In the matter of Applications for resource consents, and a Notice of Requirement for a Designation, by Wellington Water Limited on behalf of Upper Hutt City Council, for the construction, operation and maintenance of the structural flood mitigation works identified as the Pinehaven Stream Improvements Project

Memorandum of counsel for Wellington Water Limited in response to 2nd Minute of Independent Hearing Panel

Dated 16 July 2020

Figure 2 – MIKE21 Resistance Grid

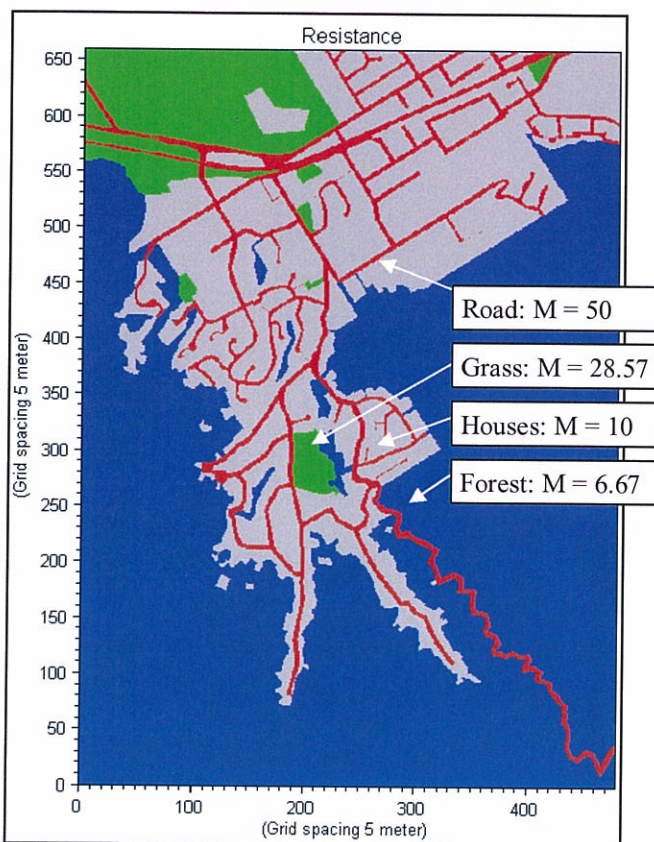
Four different values of resistance have been defined. These represent road pavement, houses, grass land and forest. Based on visual inspection of aerial photographs the number of regions and the Manning's M values defined for these regions are generally appropriate. However, it should be noted that Manning's M of 6.67 for forest may be found to be too rough during model calibration (refer **Figure 2**).

- Change the Max dx value to 5m for all branches;
- Rectify non-monotonically increasing conveyance curves via cross section settings;
- Change the Delta value in Hydrodynamic Parameter file from 0.85 to 0.7;
- Review resistance values for pipes and culverts with a Manning's n of 0.015 and open channel cross section with a Manning's n of 0.2; and
- Review the mflateral.txt data to identify coupled locations with large differences between the MIKE21 bathymetry and MIKE11 cross section bank markers.

Figure 3 – Elmslie_RD CH 453 – Non Monotonically Increasing Conveyance Curve

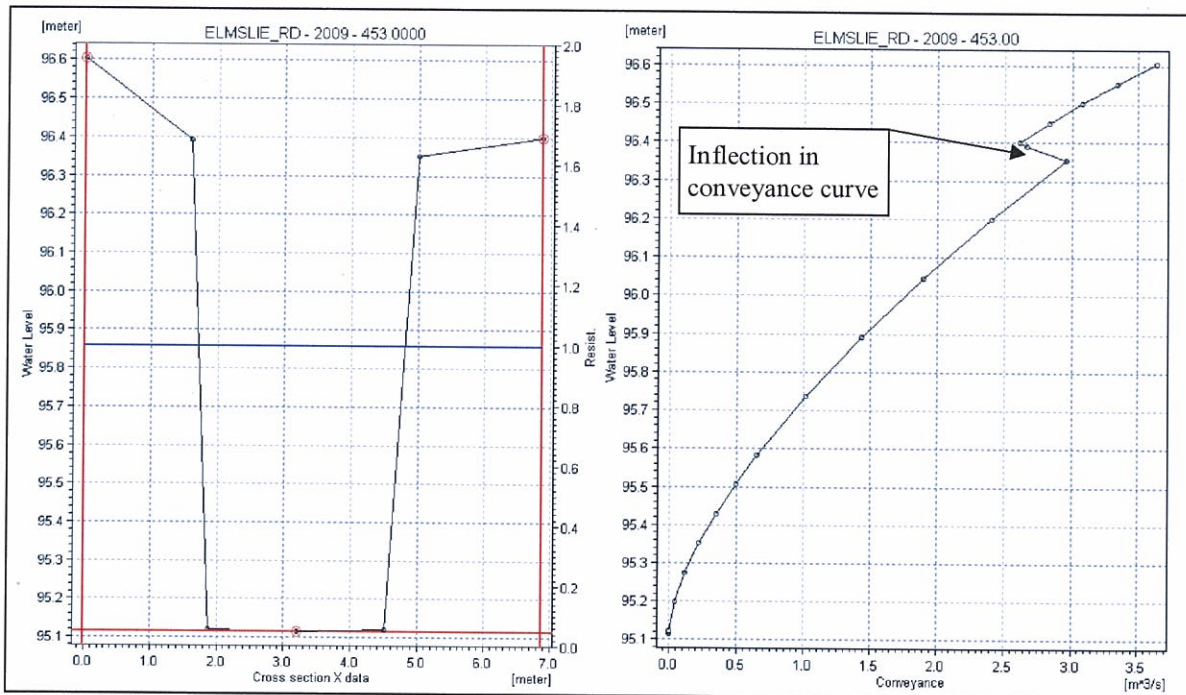
A number of cross sections within the model have non-monotonically increasing conveyance curves. An example of this is Emislie_Rd CH 453 (refer to **Figure 3**). This results from a discontinuity in the hydraulic radius curve, due to a large increase in wetted perimeter with a small increase in area (water level) and typically occurs where the flow transitions from channel to floodplain. The inflection can be corrected in two ways; first by using the left and right banks markers (markers 4 & 5) at the channel banks forcing the conveyance to be calculated in different zones and second by selecting 'Resistance Radius' over 'Total Area Hydraulic Radius' in the Radius Type drop down box within the Cross Section editor for cross sections where this occurs (refer to **Figure 4** for corrected cross section and conveyance curve). Alternatively, bank markers 1 and 3 could be moved in to the channel bank location to reduce the low flow cross section, resulting in flow being transferred to the MIKE21 grid at lower water levels. This should be done in tandem with assessment of the z values in the MIKE21 bathymetry to which these cross sections will be coupled. Selecting the equidistant level selection method in the processed data cross section editor will also assist in smoothing the conveyance curve.

Figure 5 – Chart of Selected Structure/Levee Level versus MIKE11 and MIKE21 model levels for Elmslie_Rd 475 m.

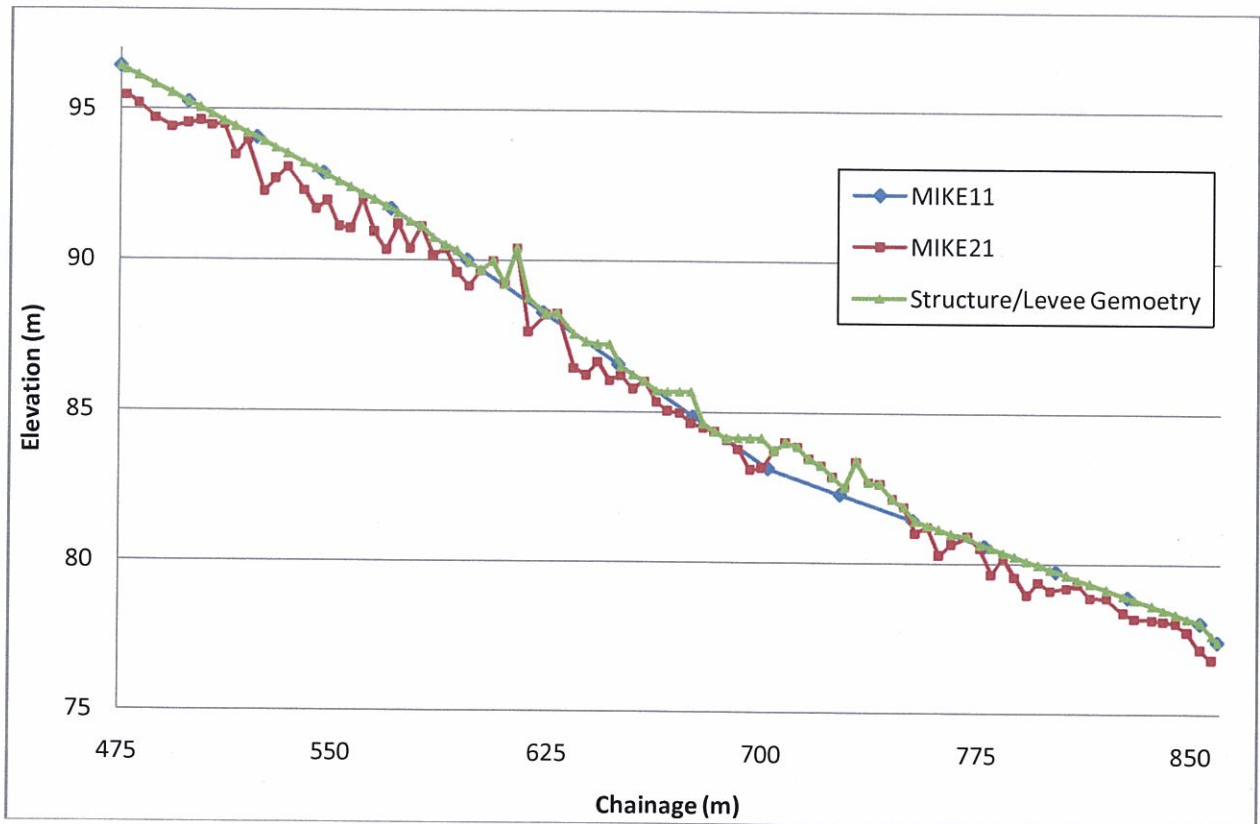
For each lateral couple the MIKE11 bank marker level, the MIKE21 bathymetry level and the structure level (or internal weir geometry) is visible (Refer to **Figure 5**). The effect of significant difference between MIKE21 and MIKE11 levels is to control the points along the couple where transfer between the two surfaces is possible. A maximum difference of 0.5m is generally recommended and either selection of a different bank marker location or filling of the bathymetry may be used to achieve this.

Figure 5.2 Flood extent elements

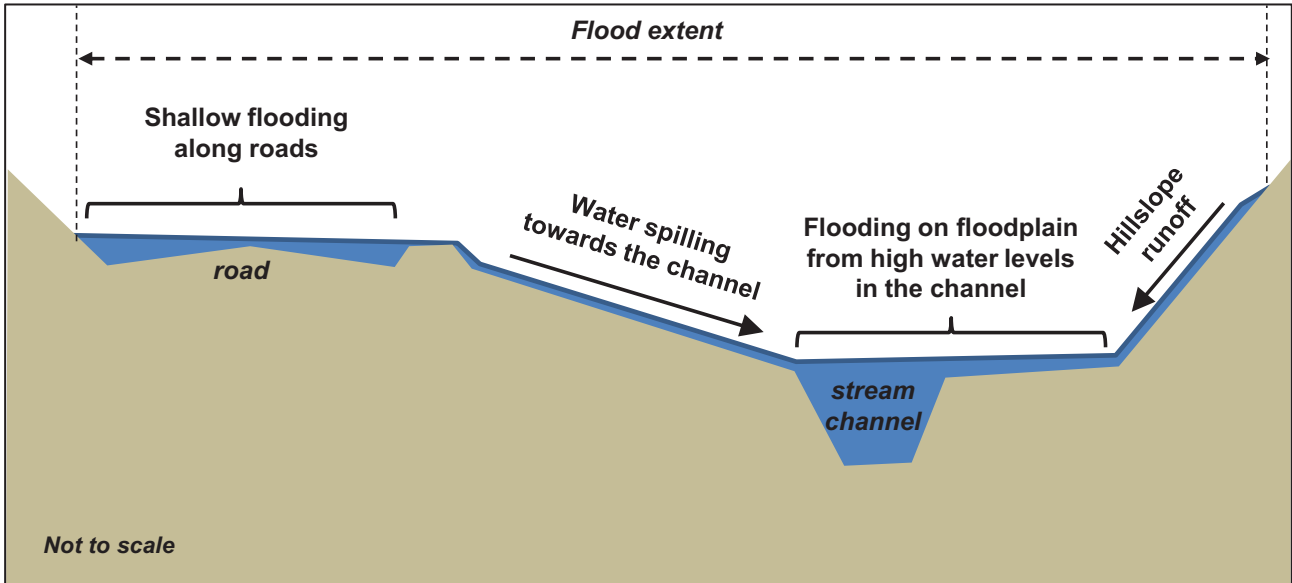
Figure 5.2 represents some of the elements that could contribute to the definition of the flood extent; illustrating why:

- The flood level may be different on opposite sides of a valley when 2D modelling is used.
- Why it may be inappropriate to assume that the water surface is flat across the flood extent.

As well as inundation of the floodplain adjacent to the stream channel, the flood extent may be extended laterally by hillslope runoff towards the channel, secondary overland flow paths (such as roads), and water spilling between secondary flow paths and the stream channel.

Figure 8.1 – Existing and maximum probable development hydrographs

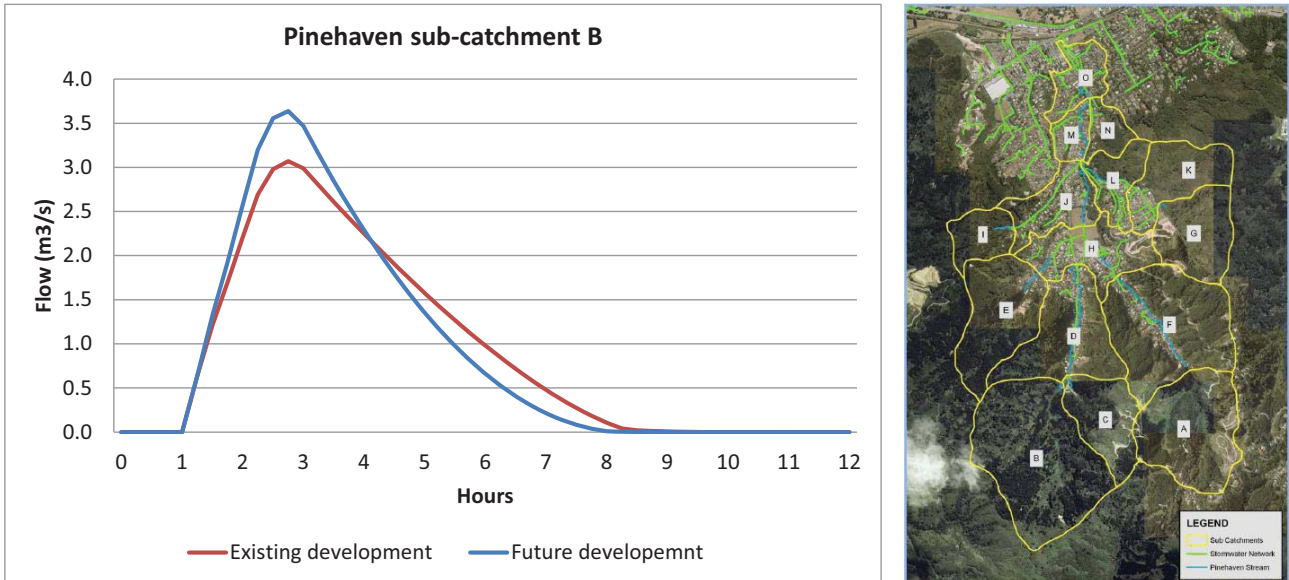
Figure 8.1 shows the change in flood hydrographs for existing development (*E4_Q100CC_2hr_HB.bnd11*) and future development (*E4_Q100CC_FP_2hr_HB.bnd11*) for sub-catchment B, which is in the southwest of the catchment and drains to the top of Pinehaven Road. Future development increases the peak flow by 18% (from 3.07 m³/s to 3.64 m³/s), and the flow recession is steeper than for the existing land use. However, the flood volume does not increase. This is unexpected, as increasing the impervious area of sub-catchment by 40% to reflect the development would be expected to reduce rainfall losses and increase runoff volume. Similar results were found for sub-catchment E, which drains to Wyndham Road.

- 76.7 mm (88%) for existing land use
- 80.8 mm (93%) for post-development land use

The difference between existing and post-development flood volumes would be expected to be to a similar ratio. The existing ground cover of bush and pine forest on sloping catchments generated relatively high runoff, when compared to natural vegetation on flatter ground. This is reflected in the 88% effective rainfall for the existing situation and only 5.6% increase in effective rainfall post-development.

Figure B.1 – SOH slide 1 for 27 Elmslie Road

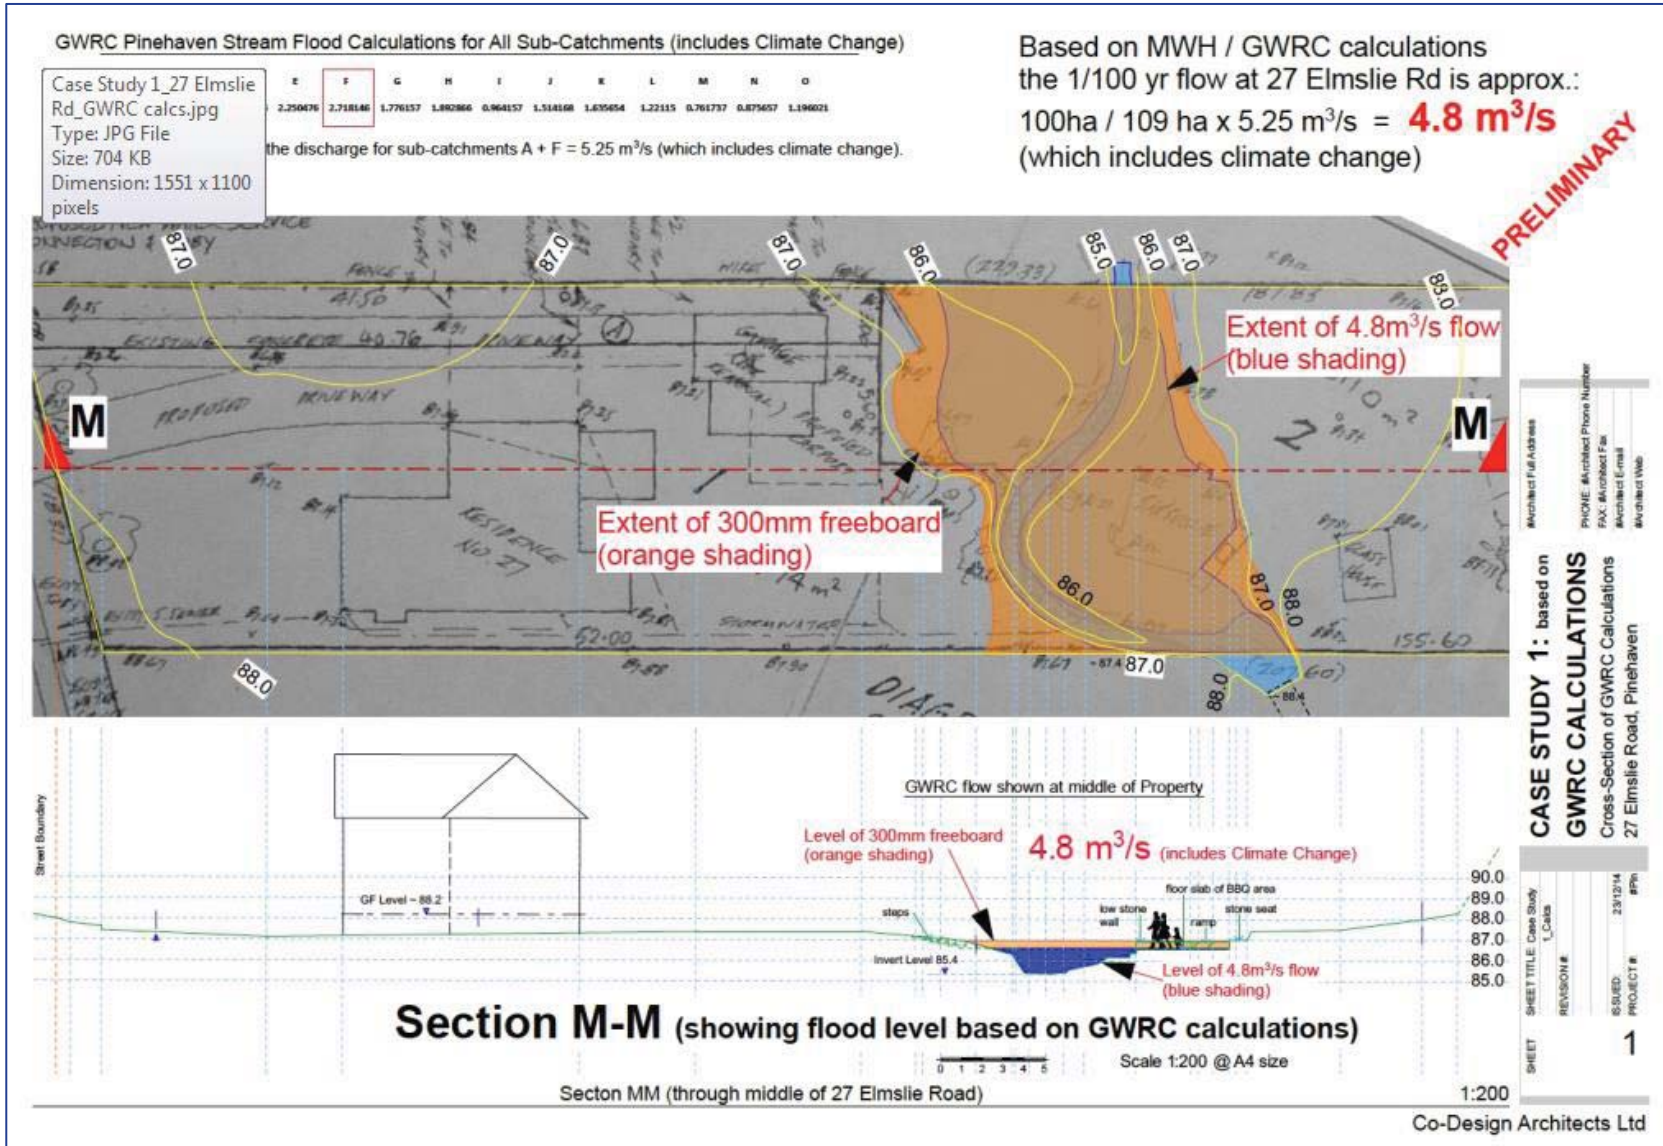
Figures B.1 and B.2 in Appendix B show the information provided by SOH for 27 Elmslie Road. At this location, the Flood Hazard Map extent is approximately 70 m wide, stretching from edge of Elmslie Road to approximately 15 m beyond the stream channel on the true right (east) bank.

Elmslie Road runs along a relatively narrow valley containing a tributary of Pinehaven Stream. At No. 27, the edge of the road is approximately 50 m from the stream, with the property between the road and the stream. The ground cross-sections produced by SOH and contained within the 5 m gridded model bathymetry show that ground level around the house to be about 1.0 m to 1.5 m below road level, while SOH's cross-section indicate that the bed of the stream is a further 2 m lower.

Figure B.2 – SOH slide 2 for Elmslie Road

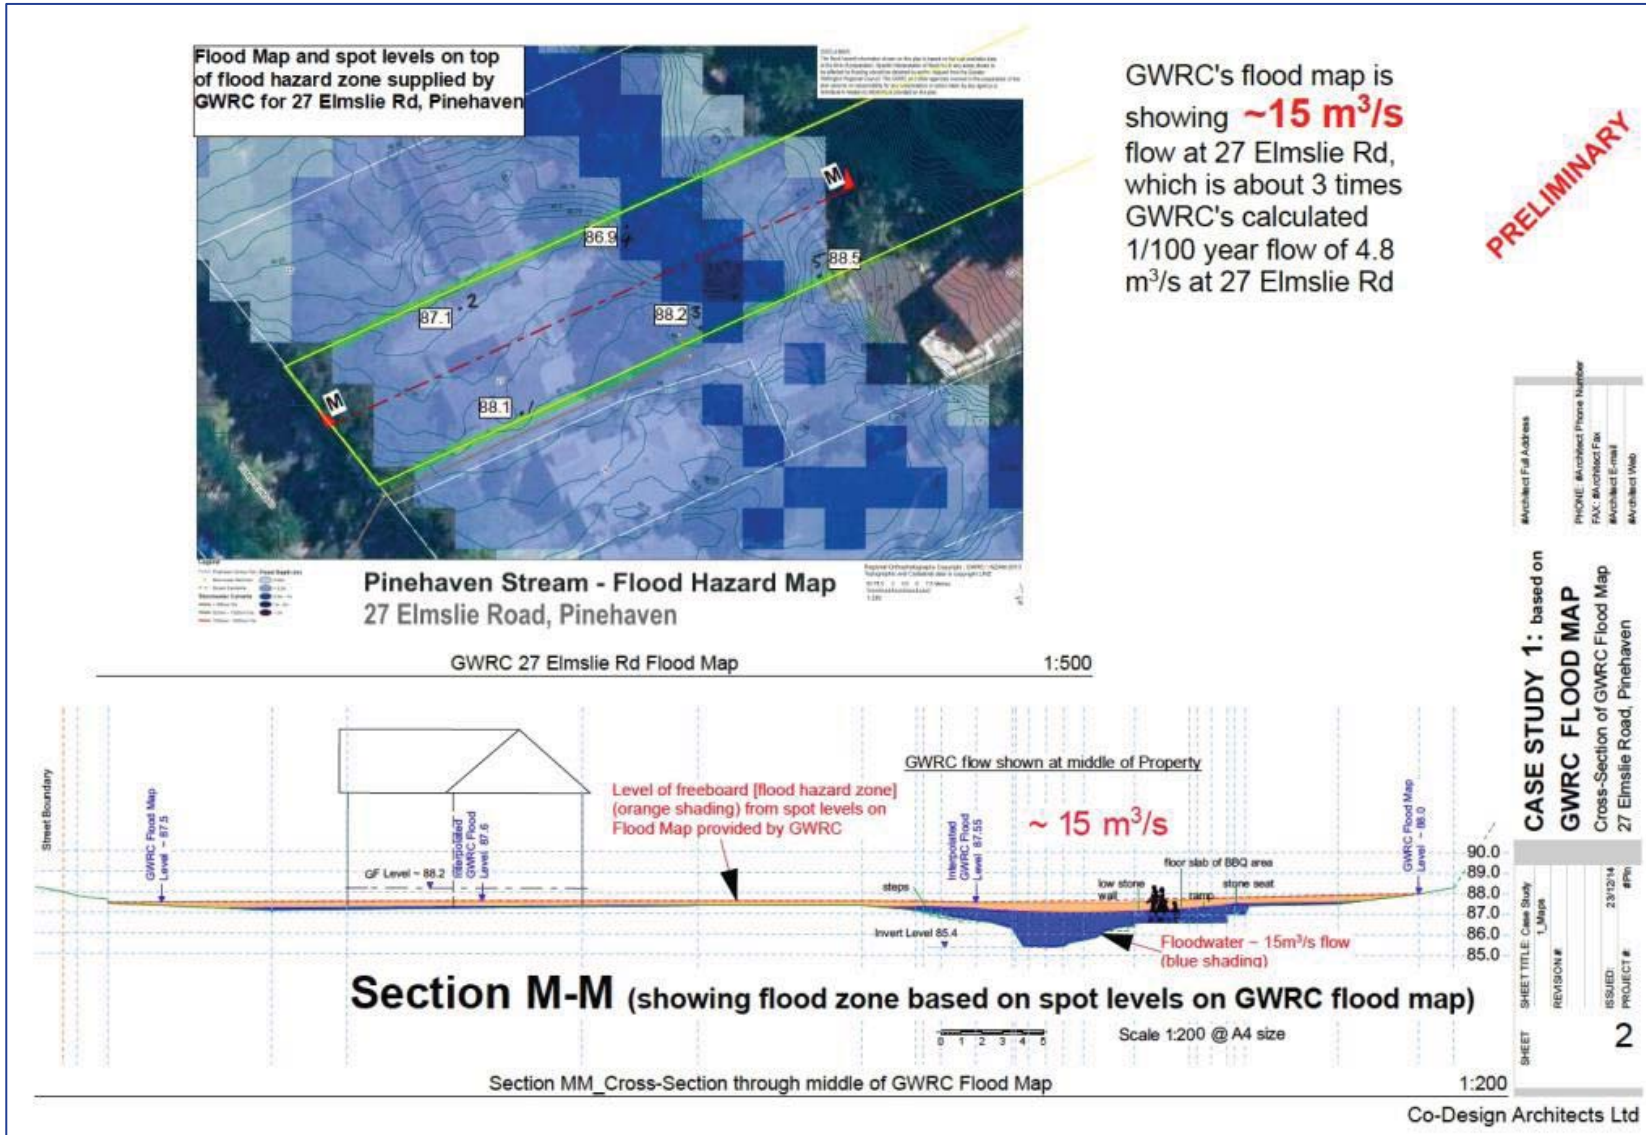
One critical area of difference between SOH's understanding of flood/hazard extents relates to the water surface across the cross-section. As noted above, SOH assumed that the water surface is flat, while SKM have provided cross-sections that indicate that the water level varies across the cross-section. Figure B.3 in Appendix B shows modelled water levels for SKM's sections in the vicinity of 27 Elmslie Road. The water levels were extracted from the 2D surface model results. They indicate shallow flooding (as low as 10 mm) at the margins of the floodplain, and lower water levels in the main channel. This may be due to overland flow paths on the floodplain carrying flow that has broken out from the stream channel upstream.
